B 3.9 REFUELING OPERATIONS

B 3.9.1 Boron Concentration

DOC Number	DOC Text						
A.01	<p>In the conversion of Point Beach current Technical Specifications (CTS) to the proposed plant specific Improved Technical Specifications (ITS), certain wording preferences or conventions are adopted which do not result in technical changes (either actual or interpretational). Editorial changes, reformatting, and revised numbering are adopted to make the ITS consistent with the Standard Technical Specifications, Westinghouse Plants, NUREG-1431, Revision 1 (i.e., Improved Standard Technical Specifications (ISTS)).</p> <table><thead><tr><th>CTS:</th><th>ITS:</th></tr></thead><tbody><tr><td>15.03.08.03</td><td>LCO 3.09.02</td></tr><tr><td>15.04.01 T 15.04.01-01 03</td><td>SR 3.09.02.02</td></tr></tbody></table>	CTS:	ITS:	15.03.08.03	LCO 3.09.02	15.04.01 T 15.04.01-01 03	SR 3.09.02.02
CTS:	ITS:

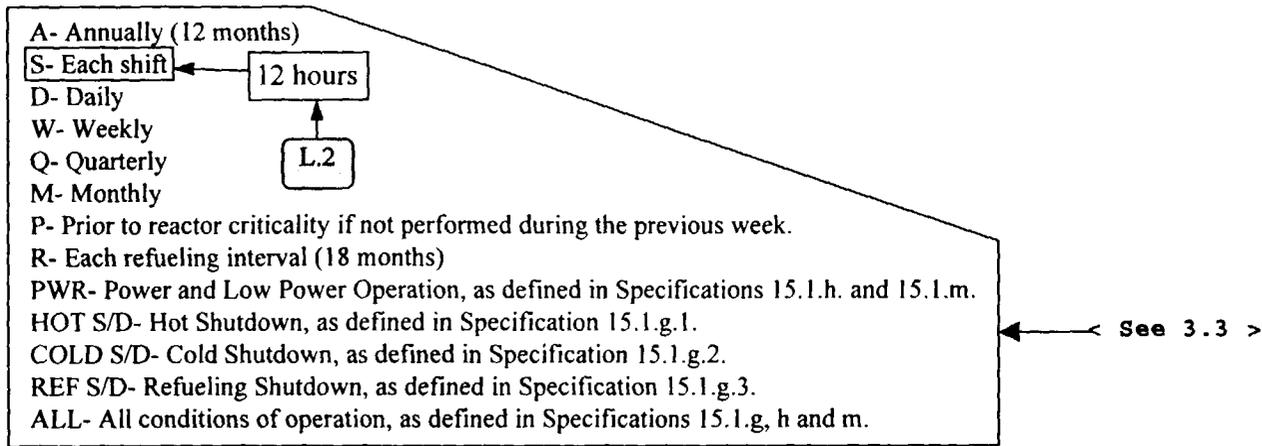
Annotations:
 - L.1 points to "Insert 3.9.3-4, New SR 3.9.2.2 Note" which points to the "S" check for row 3.
 - L.2 points to "12 Hours" which points to the "S" check for row 3.
 - A.3 points to "MODE 6" which points to the "ALL" plant conditions for row 3.
 - "See 3.3" annotations point to PWR, ALL, and ALL conditions in rows 1, 3, and 5.

CTS:	ITS:						
15.04.01 T 15.04.01-01 03	SR 3.09.02.02						
15.04.01 T 15.04.01-01 03.A	SR 3.09.02.01						
L.01	<p>CTS Table 15.4.1-1, item 3, CHANNEL CALIBRATION requirement for the neutron source range instrument channels is modified in ITS SR 3.9.2.2 by a Note, that excludes the neutron detectors from the calibration. This is a relaxation of requirements and is less restrictive. This is acceptable because the neutron detectors are passive devices with minimal drift and because of the difficulty associated with simulating a signal.</p> <table><thead><tr><th>CTS:</th><th>ITS:</th></tr></thead><tbody><tr><td>NEW</td><td>SR 3.09.02.02 NOTE</td></tr></tbody></table>	CTS:	ITS:	NEW	SR 3.09.02.02 NOTE		
CTS:	ITS:						
NEW	SR 3.09.02.02 NOTE

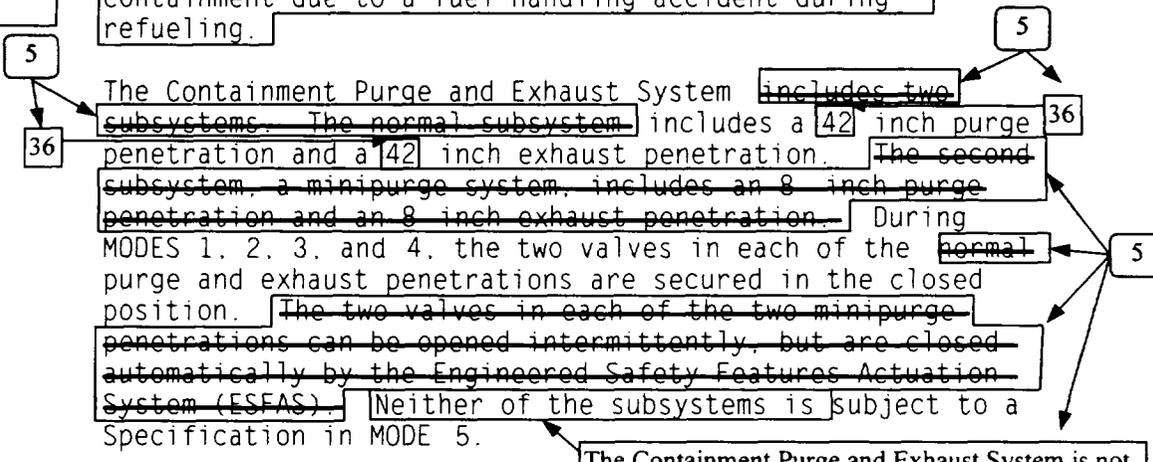
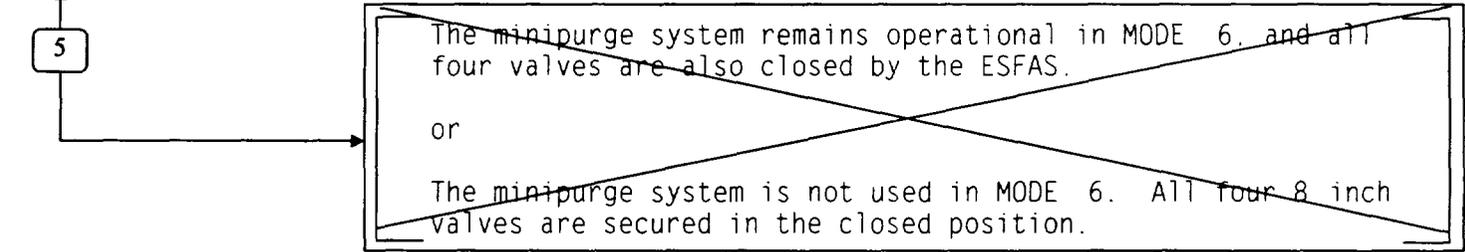
The Containment Purge and Exhaust System ~~includes two subsystems. The normal subsystem includes a 42 inch purge penetration and a 42 inch exhaust penetration. The second subsystem, a minipurge system, includes an 8 inch purge penetration and an 8 inch exhaust penetration.~~ During MODES 1, 2, 3, and 4, the two valves in each of the ~~normal~~ purge and exhaust penetrations are secured in the closed position. ~~The two valves in each of the two minipurge penetrations can be opened intermittently, but are closed automatically by the Engineered Safety Features Actuation System (ESFAS). Neither of the subsystems is subject to a Specification in MODE 5.~~

In MODE 6, large air exchangers are necessary to conduct refueling operations. The ~~normal 42 inch~~ purge system is used for this purpose, and all four valves are closed by the ESFAS in accordance with LCO 3.3.2, "Engineered Safety Feature Actuation System (ESFAS) Instrumentation."
